Document Title: Generic Environmental Impact Statement for License Renewal of Nuclear Plants, Supplement 22, Regarding Millstone Power Station, Units 2 and 3

Re: **Draft Report For Comment on Generic Environmental Impact Statement for License Renewal of Nuclear Plants, Regarding Millstone Power Station, Units 2 and 3, NUREG-1437, Volumes 1 and 2, Supplement 22**

Re: Draft Supplemental Environmental Impact Statement (DSEIS) for License Renewal of
Nuclear Plants at the Millstone Power Station, Units 2 and 3, NUREG-1437, Supplement 22
(EPA ERP #NRC-B06005-CT)

**Additional Detailed Comments
Draft Supplemental Environmental Impact Statement (DSEIS) for
License Renewal of Nuclear Plants at the Millstone Power Station, Units 2 and 3,
NUREG-1437, Supplement 22**

Figure 6-1
Strontium-90 in Milk

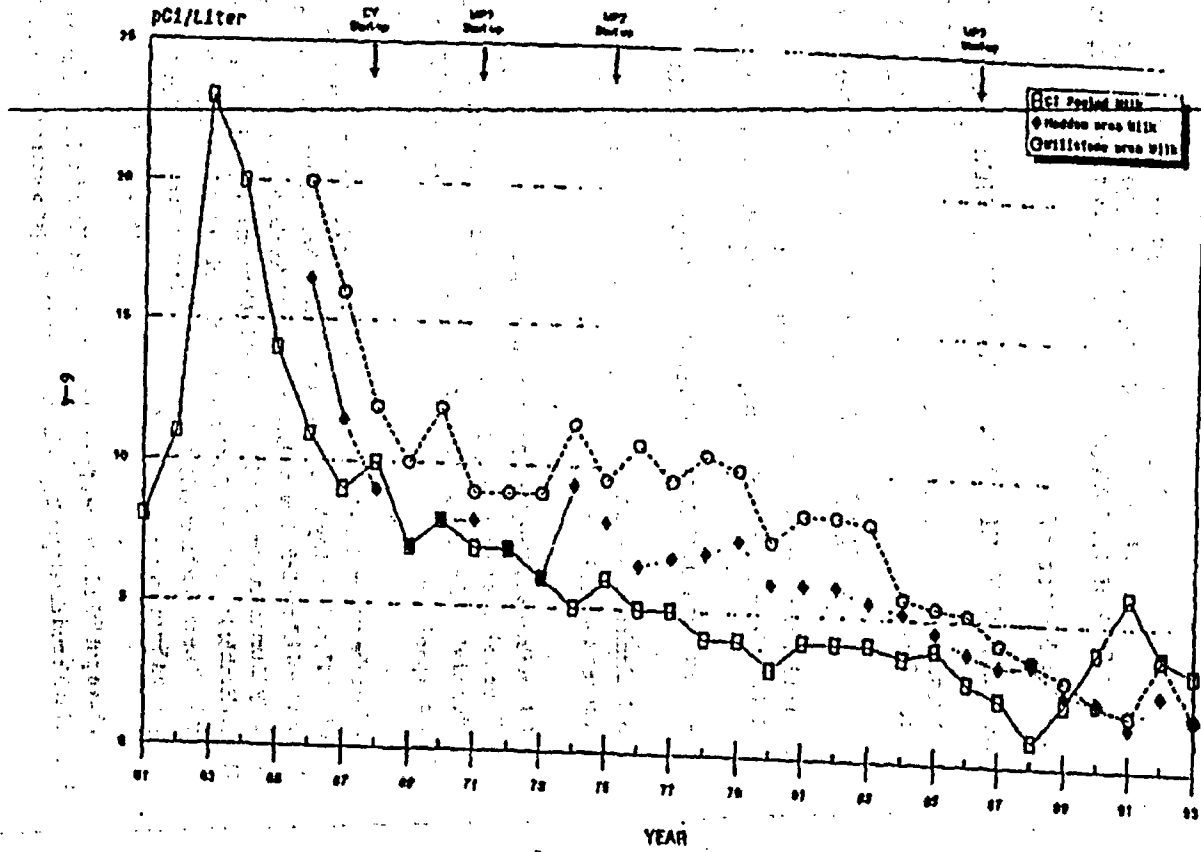
MPS-51-4 The reported samples of measurements show concentrations of 13 to 14 pCi/l on other days during the three-year period. According to Dr. Sternglass, these are also significantly high readings since strontium-90, concentrating in milk due to atmospheric nuclear weapons testing which ended in 1980, has declined to less than 1 pCi/l in areas far removed from any nuclear reactors.

Thus, in the enclosed copy of Table 8 of the Report for the year 2001, a concentration of 55.5 picoCuries per liter (PCI/L) of milk of Strontium-90 was reported for Location 22 for the sample measured on September 19, 2001, with an uncertainty of plus or minus 5.3 PCI/L. This is an extremely large concentration, close to twice the highest concentration measured in Connecticut pooled milk at the height of nuclear weapons testing in 1963 of 23 PCI/L, as can be seen from the enclosed Figure 6-1 prepared by the Dominion Company for the period 1961 to 1993. Moreover, since the measured value is ten times as large as the measurement uncertainty, this is an extremely significant result, with an astronomically small chance that it is a statistical fluctuation.

As the enclosed samples of measurements show, concentrations of 13 to 14 PCI/L were found on other days, again significantly higher than the measurement uncertainty of 1-2 PCI/L.
